BHML Industries Ltd.

Kamarjuri, Natun Bazaar, National University, Gazipur

18 February 2015

Heavy floor build up under toilets

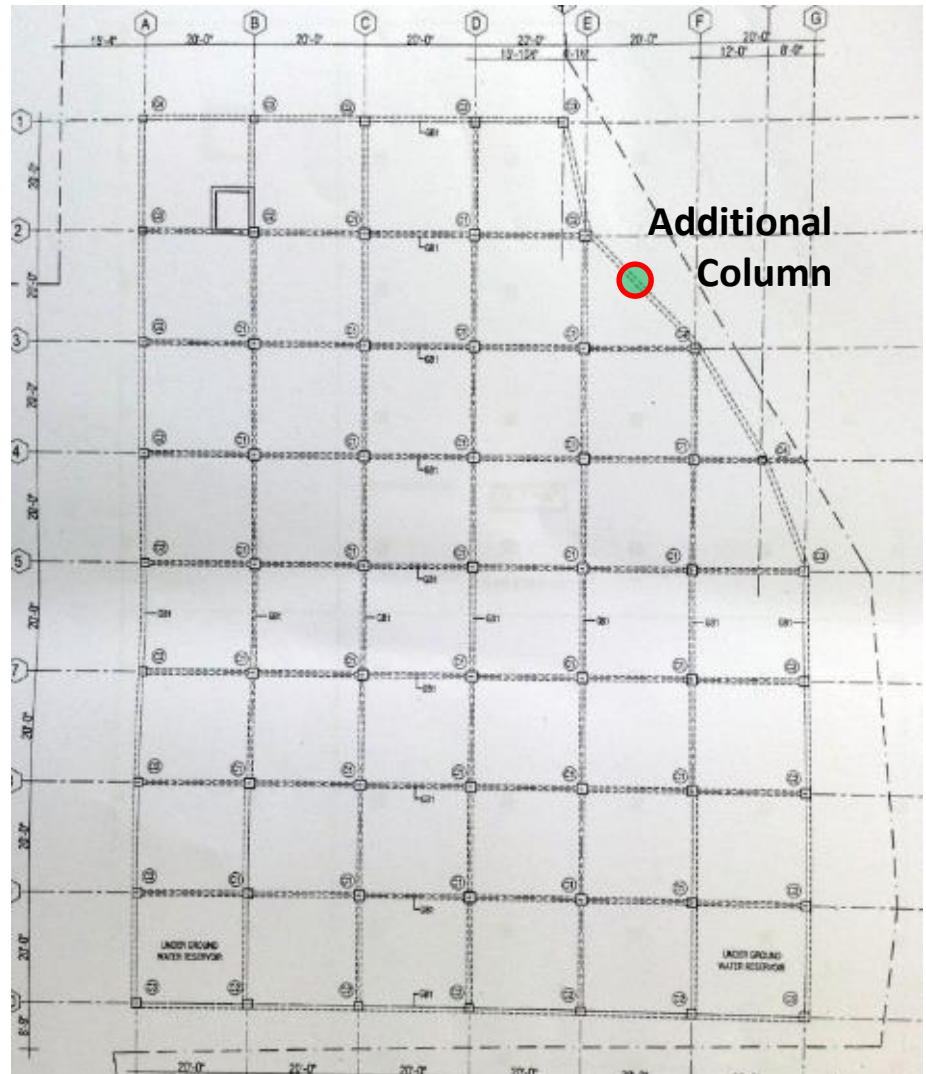
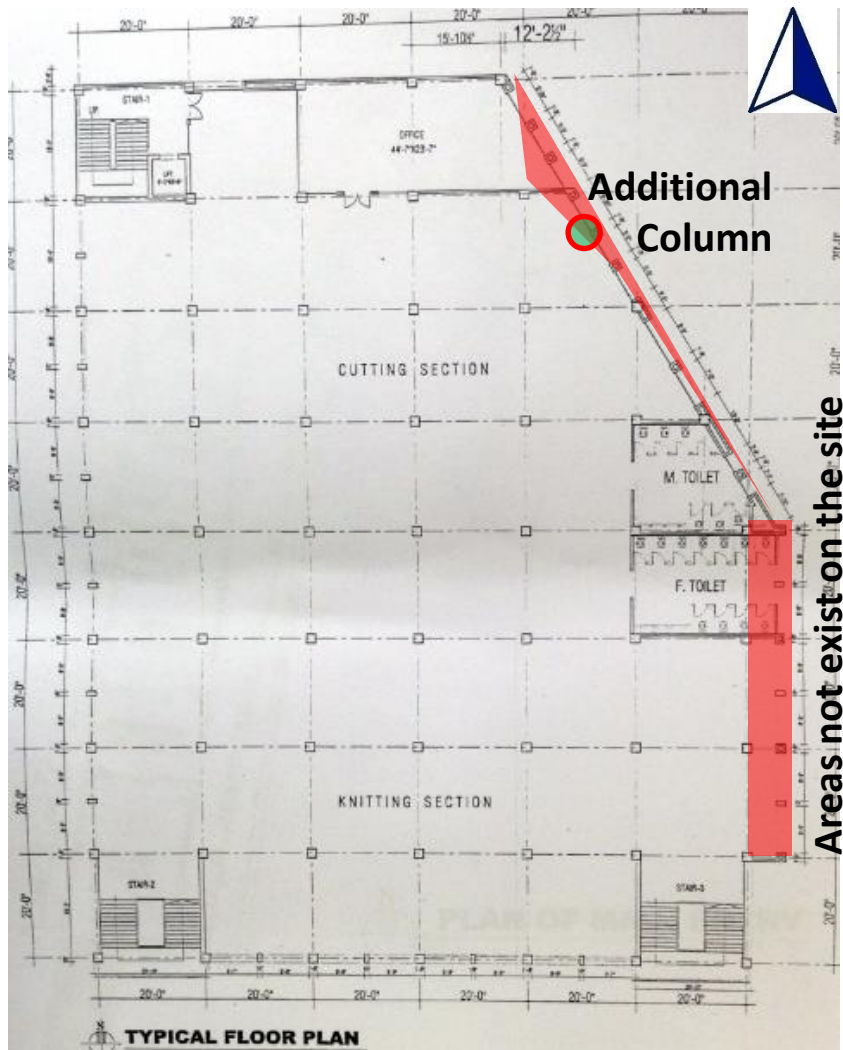
Build-ups observed in the toilet area.

ITEM 1: High loads in the toilet columns after proposed extension to 6 storeys completed. (Loads satisfactory at present)

Item No.	Observation	Recommended Action Plan	Recommended Timeline
1	High loads on the columns in the toilet zone after completion of proposed extension to 6 storeys	Factory Engineer to review design , loads and all column stresses and confirm in situ concrete strength if extension to proceed.	6-weeks
2	High loads on the columns in the toilet zone after completion of proposed extension to 6 storeys	Upward extension should be put on hold until the completion of the engineering review	6-weeks
3	High loads on the columns in the toilet zone after completion of proposed extension to 6 storeys	Carry out the recommendations of the review.	6-months
4	Discrepancies between drawings and the as built site observations	Factory Engineer to up-date as-built drawings to reflect existing structure	6-months
5	Missing loading plans	Factory Engineer to make loading plans for each floor, based on the column, beam & slab capacity.	6-months
